SERVICE BULLETIN

To: All Dealers and Customers
Bulletin Number: B170008A
Date: 16-May-2017
Brands: McCulloch, Gardol
Product: Rear Discharge Tractor
Dates Produced: 30-Nov-2016 to 10-Mar-2017
Affected Market(s): Europe

INSPECTION AND REWORK INSTRUCTIONS

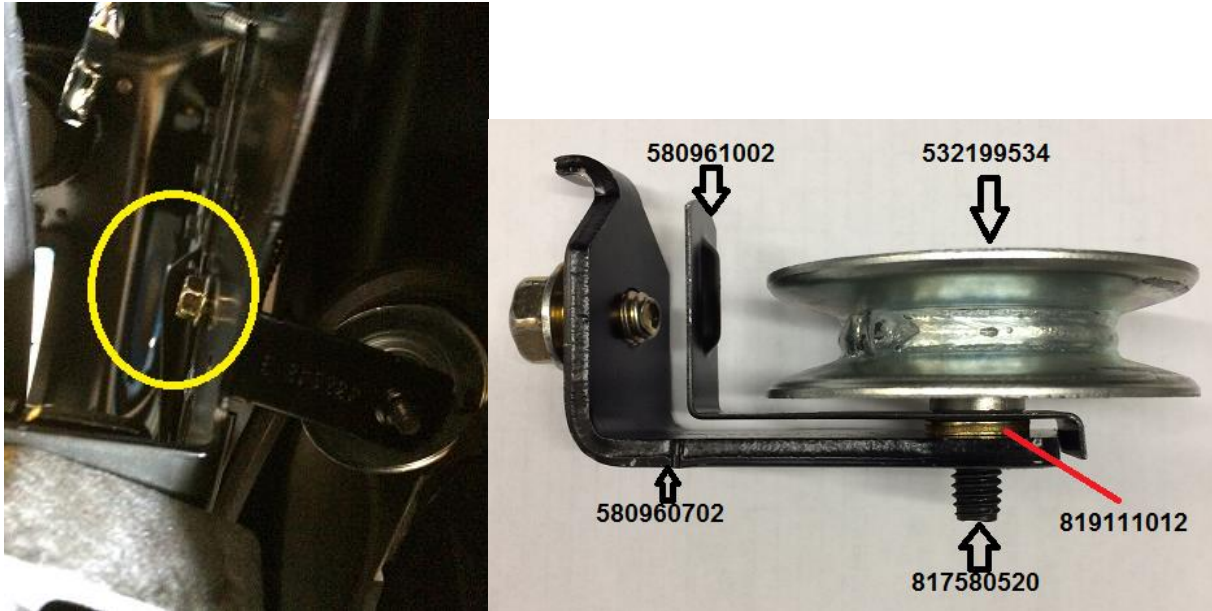
Step 2. Using a flashlight, look for the bracket on the inside of the left hand side chassis, above the rear axle shaft. Confirm part number stamped on bracket. If part number stamped is 435645, replace. If part number stamped is 580960701, bracket is correct. If correct, proceed to step 5. If incorrect, proceed to step 3.

580960701

Good part

435645

Replace part

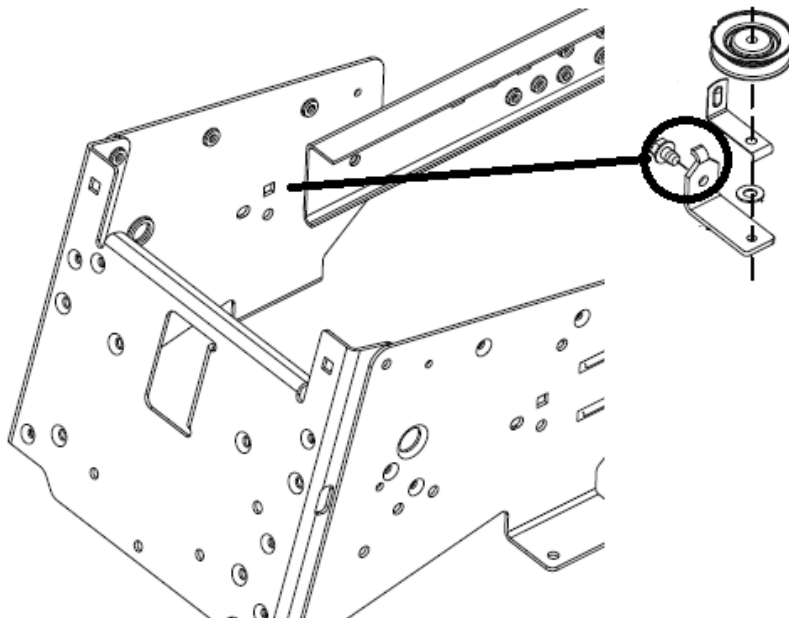
Step 3. To replace incorrect bracket, use 14 mm (9/16") wrench or socket to loosen and remove the zinc colored screw behind the left rear tire. The bracket will release from the chassis. Remove bracket and replace with preassembled bracket. Use care to not twist the belt with removing or reinstalling bracket.

Step 4. When replacing bracket, ensure tang on bracket is locked into chassis. Tighten bolt and ensure belt is between keeper and pulley.
